Intake air manifold leaking

E31, E38, E39 with M62

Fig. 1: Sealing cover on manifold, rear

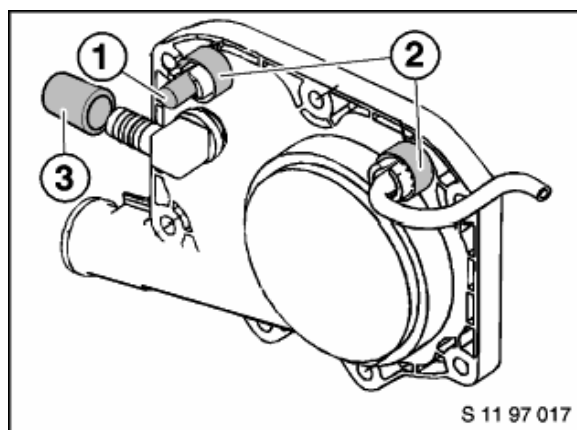
Situation: Leaks in the intake air manifold can adversely affect the idling characteristics of the M62 engine. The fault entry 27 and/or 35 with the fault type "Mixture at the Lambda oxygen sensor too lean" is stored in the DME fault memory. In such cases, the "Check engine" lamp will light up on US vehicles.
Leaks can occur

- at the gaskets between the manifold and the cylinder heads due to the different thermal expansion characteristics of the different components
- at the vacuum connections on the rear end cover of the manifold due to porous sealing caps or connections

Action: In the event of a **customer complaint**, the gaskets between the manifold and cylinder heads and the sealing caps on the vacuum connections on the rear end cover of the manifold should be replaced. In addition, the sealing cap and the vacuum connection for the fuel pressure regulating valve should be secured with a retainer ring.

- Procedure:**
1. Remove the intake air manifold
Please refer to repair instructions 11 61 050
 2. Replace the sealing cap (1) on the vacuum connection and secure it with a retainer ring (2) (please refer to Fig. 1)
 3. Secure the fuel pressure regulating valve vacuum hose with a retainer ring (2) (please refer to Fig. 1)

Note: The retainer rings (2) should be fitted so that the lugs on the retainer rings point downwards and sit against the sealing cover

4. Renew the sealing cap (3) on the vacuum connection (E31 only) (please refer to Fig. 1)
5. Install the intake air manifold using new gaskets
